Title: Information about the actual used rubber bushes in the mast		
AG-SIL-2024-01-EN		Released:
Applicability		
Aircraft type & model: Cavalon, Calidus (and MTO2017 with separated upper mast)	Affected Serial number(s): All Models with separated upper masts	1st March 2024
The maintenance manual to be referenced is this stated or subsequent issue.		As per AutoGyro website
This form is the response from AutoGyro GmbH either against a problem found in the product in service requiring a containment or rectification action, or as service information for aircraft modification incorporation. For help, contact AutoGyro, email: airworthiness@auto-gyro.com .

Reason and overview of the Service Information Letter

Illustrations and parts for the lower attachment for the Cavalon:

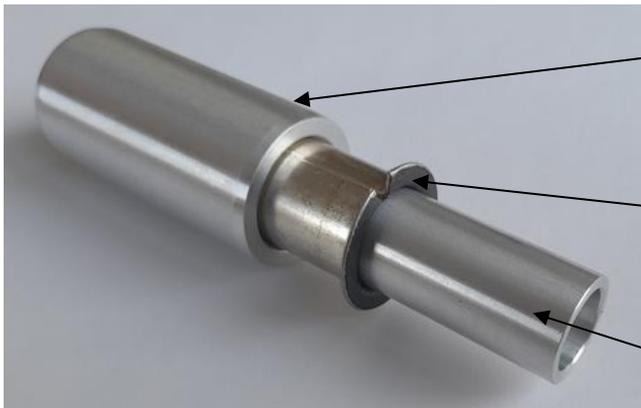
The current Cavalon and Calidus Maintenance Manual job card 62-51-00 8-1 mast bushing replacement process is based on the original twin rubber bush design. For newer models the information shown is no longer correct. There is now a metal bushing assembled in the lower mast attachment. The information below explains the difference in the assembly for the lower metal bushing.

Bushing TEF-MET, PN 45861

Bush mast top bottom, PN 45827

Clamp bush mast, PN 45826

Illustrations and parts for the upper attachment for the Cavalon:

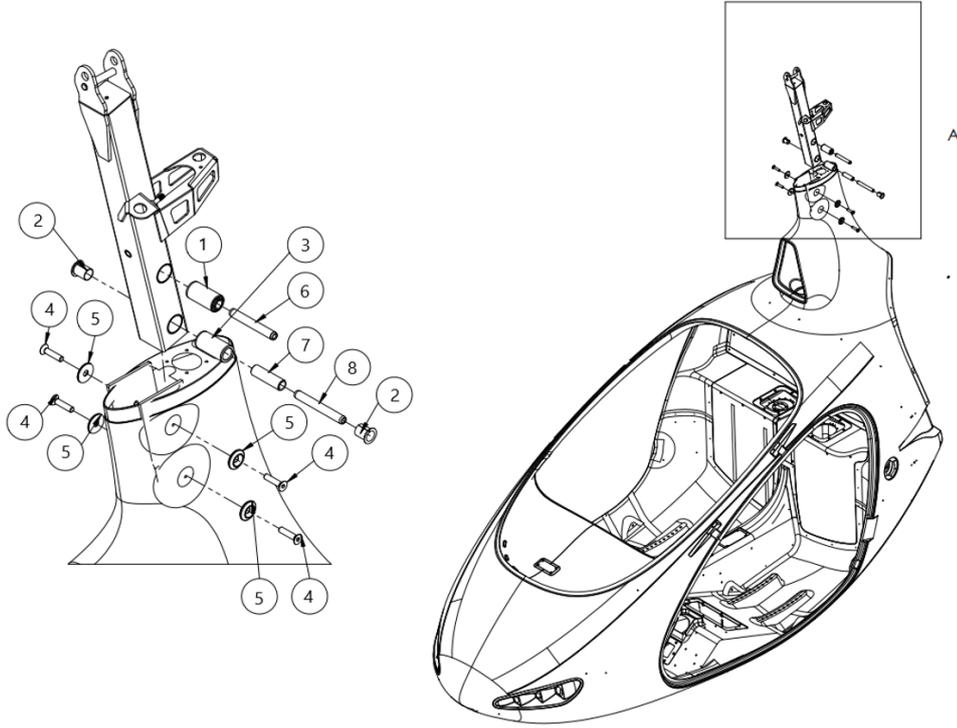
Rubber bushing, 70 shore, PN 22545 for the upper attachment point for the Cavalon. Colour marking on the rubber: white

Illustrations and parts for the upper attachment for the Calidus:

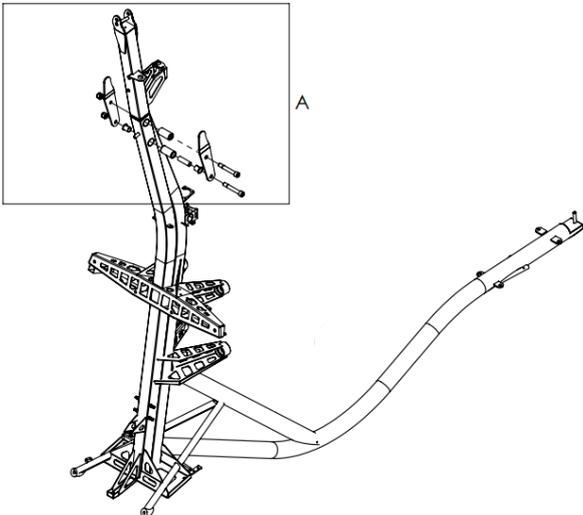
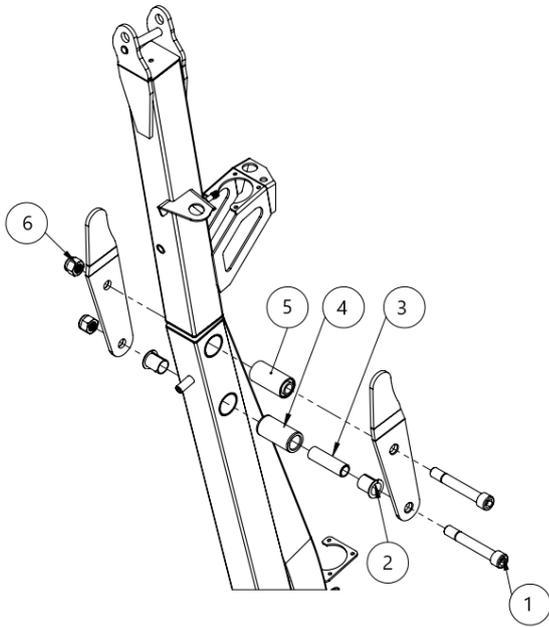
Rubber bushing, 90 shore, PN 11082 for the upper mast attachment for the Calidus. Colour marking on the rubber: orange

For the MTO2017 with the separated upper mast following parts are the latest development stage:

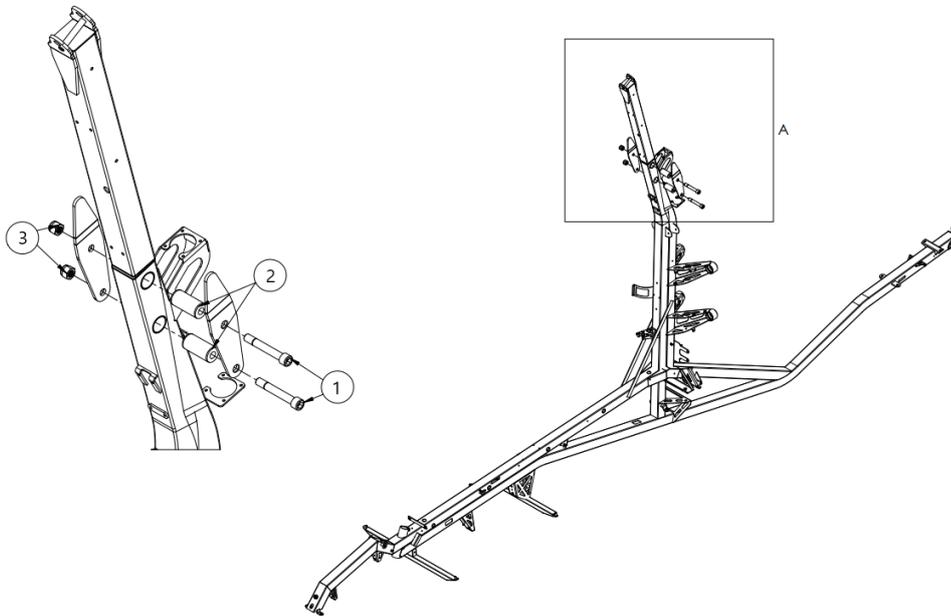
Bush mast top, PN 44214, on both attachment points
